Chapter	Section	Table / Figure	Current Living DCD page	Summary of change
Tier 1		Table 2.4.4-1	2.4-37	Recirculation system configuration change (deletion of transfer piping and refueling cavity drain piping). Addition of SSCs (e.g., valves, overflow piping, debris interceptor) per Tier 2 Table 3.2-2 change
Tier 1		Table 2.4.4-2	2.4-41	Addition of mechanical equipment (i.e., valves and debris interceptor) per Tier 2 Table 3.2-2 and 3.9-14 changes
Tier 1		Table 2.4.4-3	2.4-42	Recirculation system configuration change (deletion of transfer piping and refueling cavity drain piping). Addition of piping (i.e., overflow pipe) per Tier 2 Table 3.2-2 change
Tier 1		Table 2.4.4-5, AC#7.b.iii.b	2.4-50	RWSP water inventory change
Tier 1		Table 2.4.4-5, AC#7.b.iv	2.4-50	Strainer surface area change
Tier 1		Table 2.4.4-5, AC#7.b.iiv	2.4-51	ITAAC to verify debris interceptor design (e.g., mesh size)
Tier 1		Figure 2.4.4-1 (Sheet 4)	2.4-59	Update P&ID to be consistent with revised recirculation system configuration.

Tier 1		Table 2.11.1-2, ITAAC #4	2.11-3	Wording change to refer to floor openings between SG compartments and reactor cavity
3		Table 3.2-2	3.2-29 (sheet 13 of 56), 3.2-48 (sheet 32 o

Figure 2.4.4-1 Emergency Core Cooling System (Sheet 4 of 4)

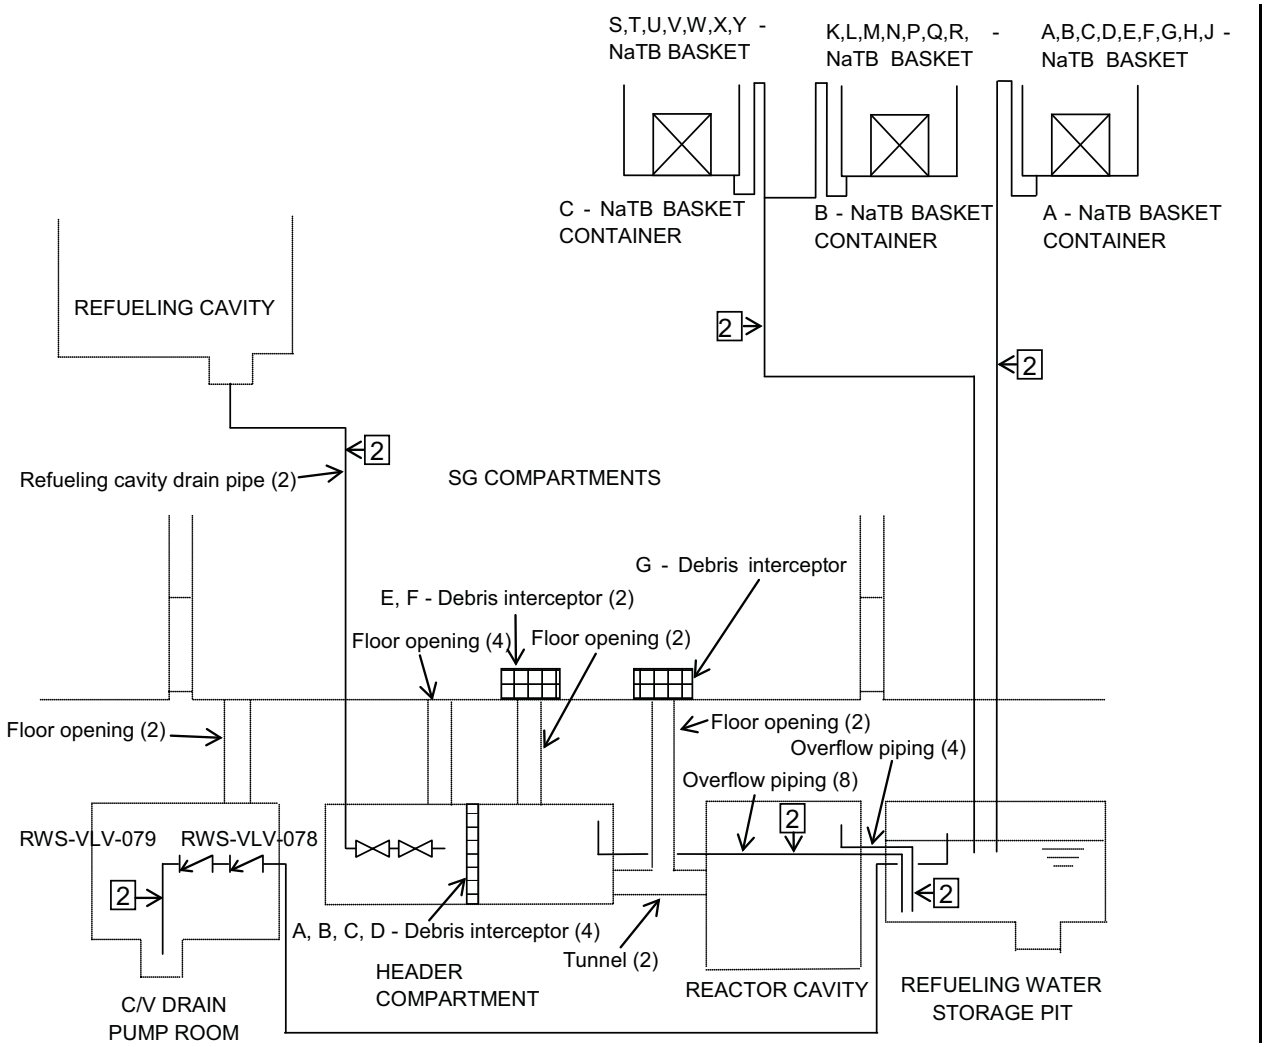
4. A set of drain ~~lines~~paths from the SG compartments to the reactor cavity exists.	4. Inspections of the as-built drain ~~lines~~paths from the as-built SG compartments to the as-built reactor cavity as shown in Figure 2.4.4-1 will be performed.	4. ~~Drain lines from the as-built SG compartments to the as-built reactor cavity exist.~~ Eight floor openings to provide drain paths from the as-built SG compartments to the reactor cavity through the header compartment as shown in Figure 2.4.4-1 exist.

Figure 6.2.1-9 ~~Outline of Paths that Solutions from the ECCS and CSS would follow in the Containment to the RWSP~~ Outline of Post-LOCA Recirculation Pathways

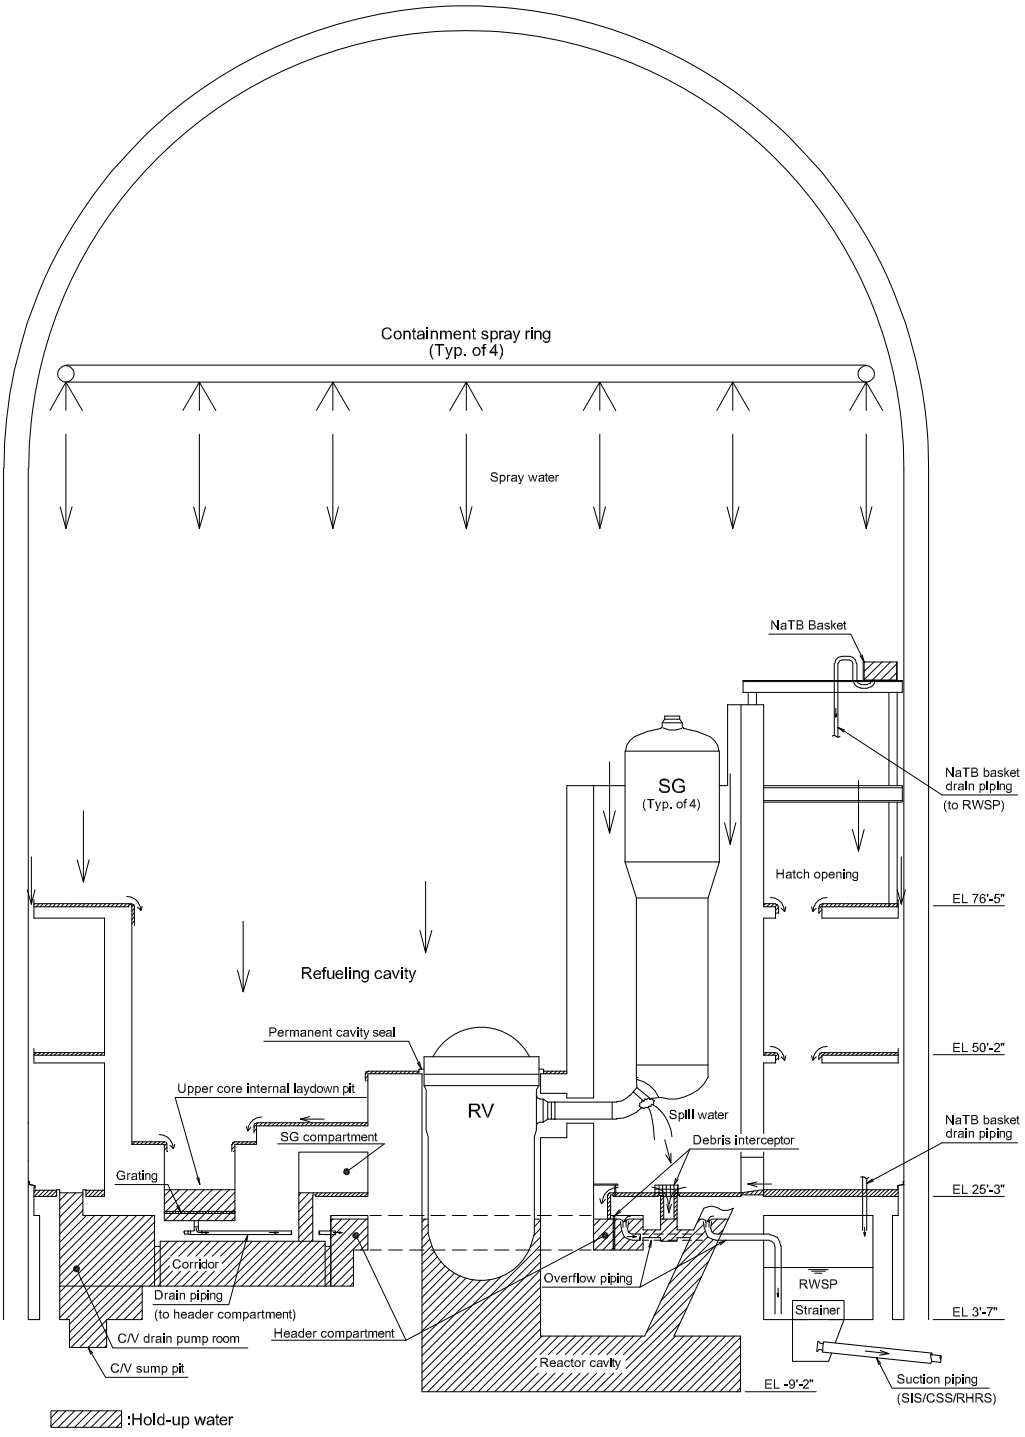
capacity to meet long-term post-LOCA coolant needs, including holdup volume losses. Potential holdup areas within the containment are depicted in Figure 6.2.1-9. ~~The transfer piping and refueling cavity drain piping serves to the replenishment functions necessary for the ECCS to perform its safety function.~~The overflow piping provides the replenishment functions necessary for the ECCS to perform its safety function. The total water volume held up in the containment is shown in Figure 6.2.2-7. Figure 6.2.2-7 shows the RWSP capacity requirements for refueling and LOCA. The RWSP is configured as a rough horseshoe-shaped box around the containment perimeter. The open end of the RWSP is oriented at the containment 0° azimuth (plant north), where the reactor coolant drain tank, reactor coolant drain pumps, and the containment sump are located. Figure 6.2.1-16 and Figure 6.2.1-17 present plan and sectional views of the RWSP. Subsection 6.2.1 describes the RWSP and its containment-related features and functions as part of the containment structure. MIC-03-06-00070

Figure 6.2.1-12 Transfer Piping

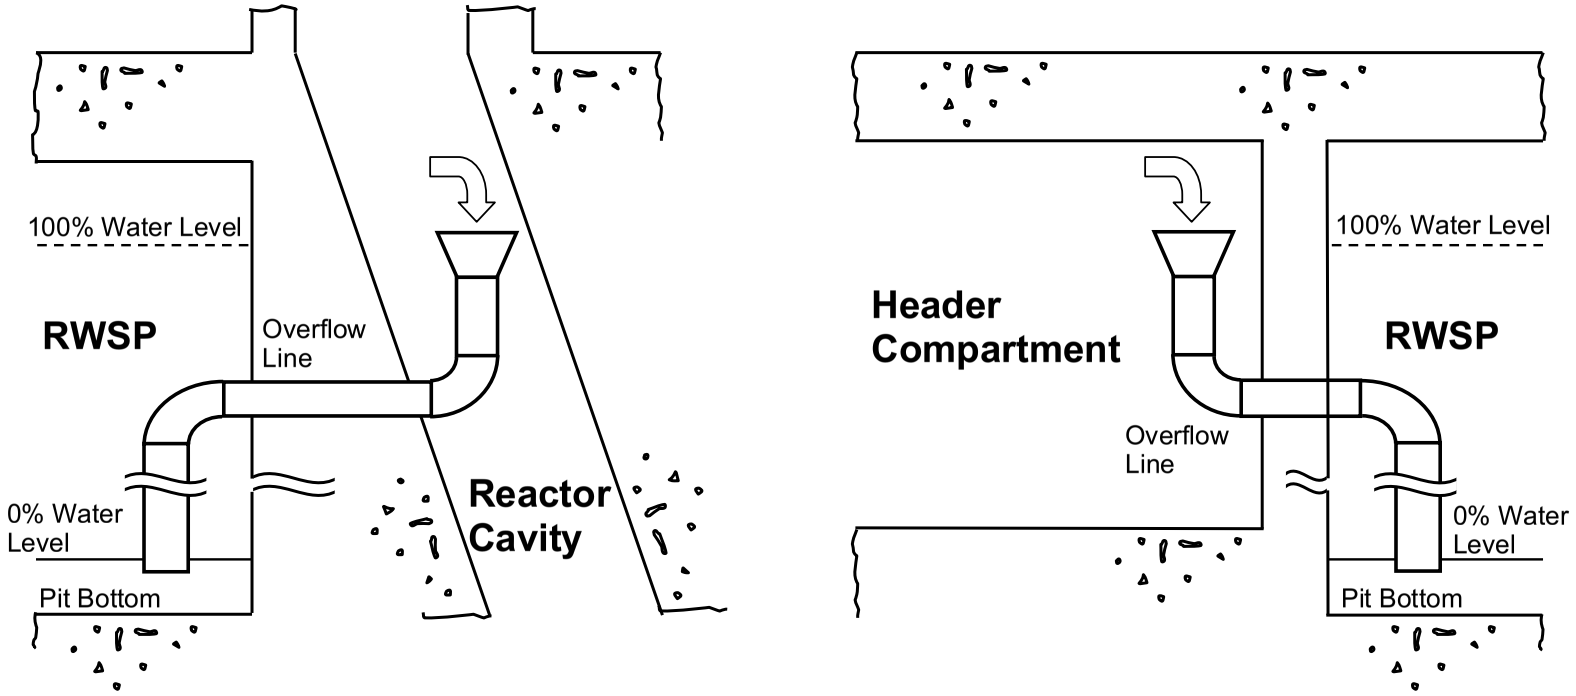
The coolant and associated debris from a pipe or component rupture (LOCA), and the containment spray drain into the RWSP through 12-in diameter overflow pipes, as shown in Figure 6.2.1-12, which provide return flow from the reactor cavity and header compartment. The reactor cavity and header compartment overflow pipes are offset from the SG compartment floor openings and refueling cavity drain piping. There are two sets of four overflow pipes from the header compartment to the RWSP, and one set of four overflow pipes from the reactor cavity to the RWSP. To minimize containment humidity (due to evaporation from the RWSP), the discharge of the overflow piping extends below the normal 100% RWSP water level. Each overflow pipe discharges into a return flow water baffle. The reactor cavity and header compartment receive containment drainage through floor openings in the SG compartments, as discussed in Subsection 6.2.1.1.2. Mesh debris interceptors are installed above the floor openings and within the header compartment as shown in Figure 6.2.1-14. The debris interceptors are designed with an 8-in x 8-in mesh, which is smaller than the overflow pipe diameter to prevent clogging of the overflow piping. The debris interceptors are necessary for ECCS operation, and are therefore classified as safety-related and seismic category I components. The header compartment also receives return flow from the refueling cavity, which is protected from large debris by grating in the upper core internal laydown pit (as discussed in DCD Section 6.2.2.3.11). The design basis of postulated debris is defined as “fines” and all of this debris is assumed to enter the RWSP in the safety evaluation of the sump performance (Reference 6.2-34).~~transfer pipes, as shown in Figure 6.2.1-12. The pipes are installed through the RWSP ceiling, ending as openings into the containment floor at elevation 25 ft. - 3 in. Each transfer pipe opening into the containment is protected from large debris by vertical debris interceptor bars that are capped by a ceiling plate. There are ten transfer pipes distributed around the containment at elevation 25 ft. - 3 in, as~~ MIC-03-06-00070

Figure 6.2.1-14 ~~Communicating Piping of HVAC Pressure Equalization Chamber~~Debris Interceptor

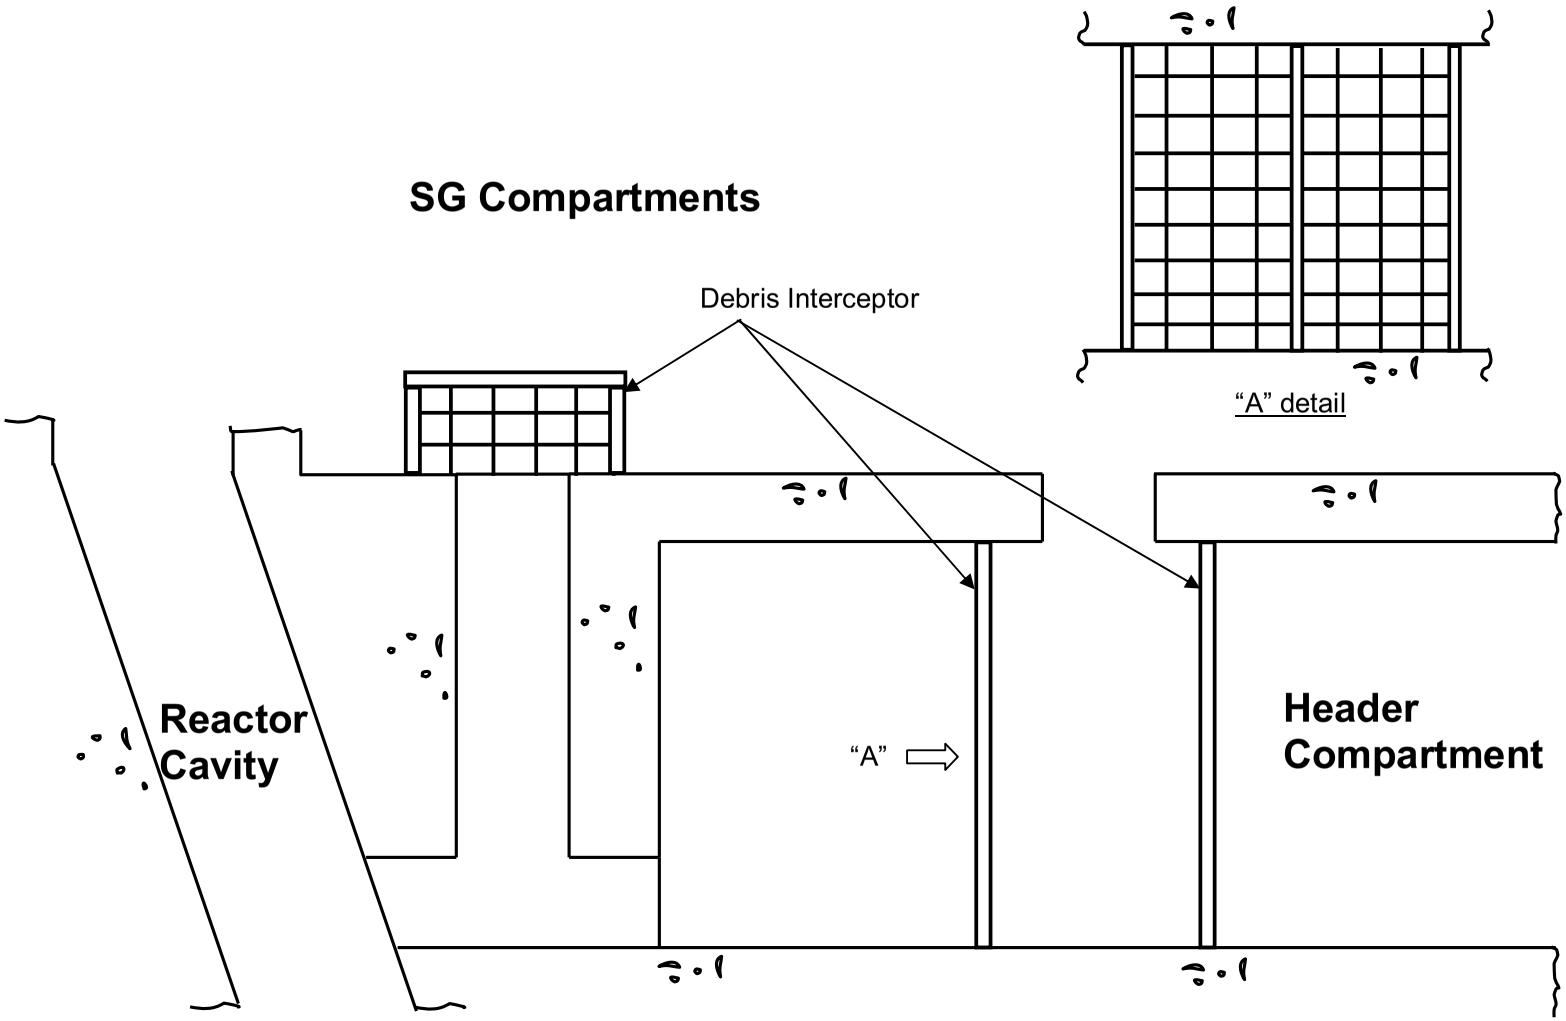
Figure 6.2.1-9 through Figure 6.2.1-15 also shows containment drainage paths into the RWSP. ~~Piping is provided through several partitions above the RWSP where water could otherwise be trapped. In particular, piping that allows free communication and drainage is installed between the refueling cavity and the pressure equalizing chamber, as shown in Figure 6.2.1-9. These communication pipes are closed with a flange at both ends during refueling. Drain piping also is provided between the pressure equalizing chamber and the RWSP.~~ Containment drainage flows through floor openings in the SG compartments to the reactor cavity, header compartment, and C/V drain pump room. Containment drainage also flows from the refueling cavity through piping to the header compartment, although this piping is closed with valves during refueling, as shown in Figure 6.2.1-13. Overflow pipes, as shown in Figures 6.2.1-12 and 6.2.1-16, are installed to transfer water from the reactor cavity and header compartment to the RWSP. The overflow pipes are protected from large debris by debris interceptors, as shown in Figure 6.2.1-14. The MIC-03-06-00070

The SG compartment debris interceptors are box-type steel mesh structures with 8 inch x 8 inch openings on the sides and a grating on top. The header compartment debris interceptors are a vertical riser-type frame with 8 inch x 8 inch mesh. For all debris interceptors, the mesh extends to a height higher than the postulated flooding level. The 8 inch x 8 inch mesh openings are sized to capture large debris that could potentially clog the overflow piping. See Figure 6.2.1-14 for the debris interceptor schematic drawing.

Figure 6.2.1-15 RWSP Overflow Piping

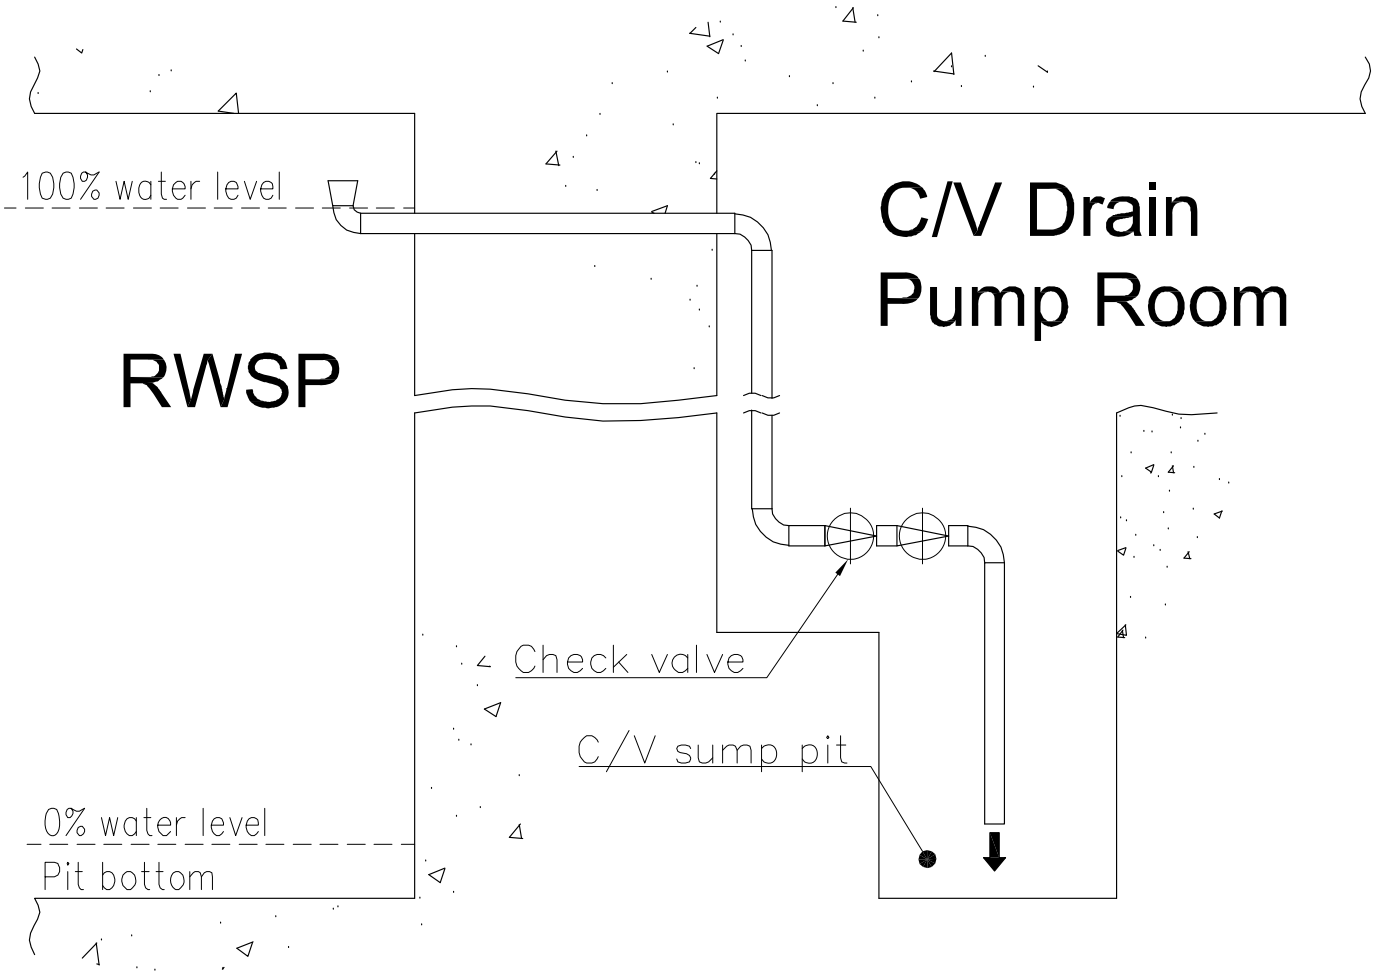
Chapter	Section	Table / Figure	Current Living DCD page	Summary of change
6		Table 6.2.2-2 (Sht 20)	6.2-204	Typographical error: disks -> disk
6		Table 6.2.2-4	6.2-210	Missed revision in May 2012 GSI-191 Tracking Report. Revised chemical debris amount as follows: Aluminum Hydroxide: 145 -> 300 lbm Sodium Aluminum Silicate: 160 -> 330 lbm
6		Figure 6.2.1-8	6.2-235	Corrected area name from "Containment recirculation air distribution chamber" to "Header compartment"
6		Figure 6.2.1-9	6.2-236	Flow path to the RWSP and transfer pipes/ Caption for figure
6		Figure 6.2.1-10	6.2-237	Hold-up water volume
6		Figure 6.2.1-11	6.2-238	RWSP Water Levels (EL of 100% water level)
6		Figure 6.2.1-12	6.2-239	RWSP Transfer Piping
6		Figure 6.2.1-13	6.2-240	Remove NaTB piping to Refueling Cavity Drain Line
6		Figure 6.2.1-14	6.2-241	Debris interceptor
6		Figure 6.2.1-15	6.2-242	RWSP overflow piping - Add check valve
6		Figure 6.2.1-16	6.2-243	Layout - Remove Transfer Pipes, add new openings and overflow pipes
